# PRIVATE BRANCH EXCHANGES, CORDLESS (C.B.S. No.1 AREAS).

N 908 24-9-21

SUPERSEDES N 910  
FOR NEW WORK.

SWITCHBOARDS CBS 364.

OPERATOR'S TELEPHONE CIRCUITS.

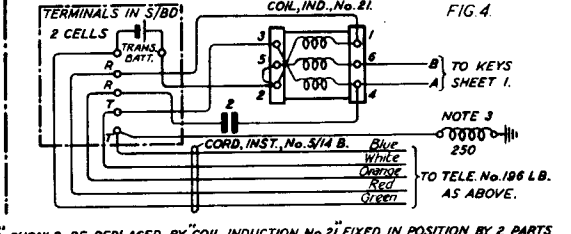
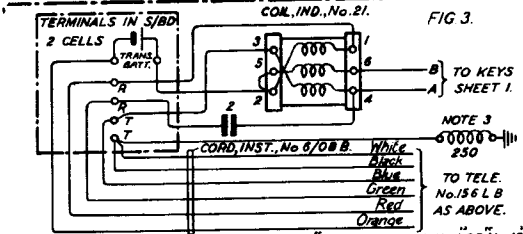
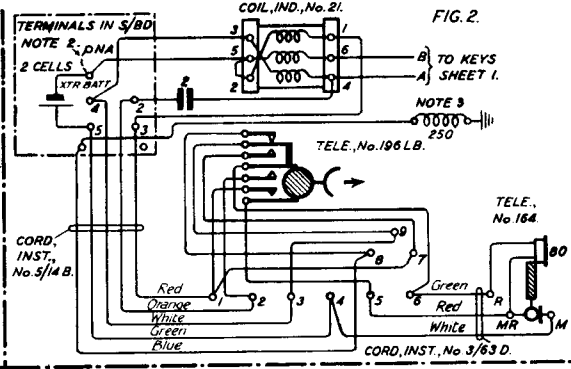
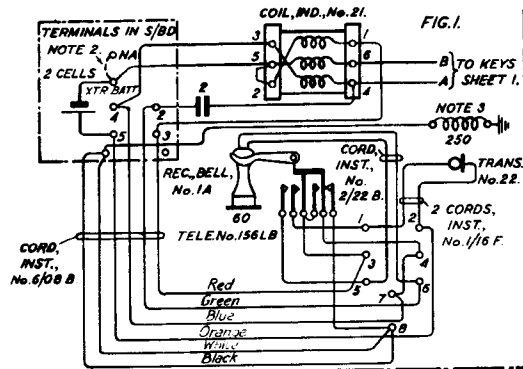
MADE YELLOW	25.7.53 J
Supersession note added.	17.4.37 H
C.B.S. No.1 Areas added to title.	9.10.24 G
Coil Ref'dn. No.13C was Coil. Bdg. Plate.	
connection. No.1 deleted. Earth connection 4-2-35 F	
added to Gen. and Indic. Cab.	
Ref'dgm. Oper's Tel. Cols. Sheet 2 added 11-9-33 E	
AMENDMENT

- NOTES: 1. FOR NEW WORK THE EXISTING "COIL INDUCTION No. 1" OR "No. 12" SHOULD BE REPLACED BY "COIL INDUCTION No. 21" FIXED IN POSITION BY 2 PARTS No. 1/139B AND A TELE. No. 156 LB. FITTED. THE CIRCUIT ARRANGEMENTS ARE INDICATED IN FIGS. 1 & 3.
2. A SEPARATE SPEAKING BATTERY SHOULD BE PROVIDED, AND THE STRAP SHOWN DOTTED DISCONNECTED.
3. ON NEW SWITCHBOARDS NOT ALREADY FITTED WITH A "COIL RETARDATION No. 13C," THE COIL SHOULD BE PROVIDED LOCALLY. ON EXISTING SWITCHBOARDS THE COIL WILL ONLY BE PROVIDED WHERE IT IS DESIRED TO GIVE A CLEAR TO THE EXCHANGE WITHOUT RESTORING THE EXCHANGE LINE KEY TO NORMAL.
